Installation of Rubber Body Plugs During PDS

Pre-Delivery Service

Avalon - Avalon HV

Figure 1. Front Tie-Down Location - Before Installation

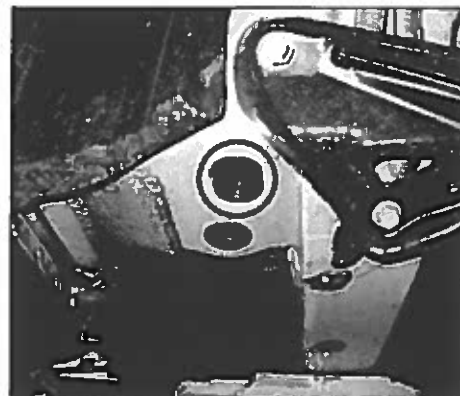
The oval-shaped rubber body plugs should be installed in the 4 torque box holes during Pre-Delivery Service (PDS).

Installation of the rubber body plugs reduces cabin noise and prevents moisture from entering the body.

See photos below that show the front/rear locations of the torque box holes with and without the rubber body plugs installed:
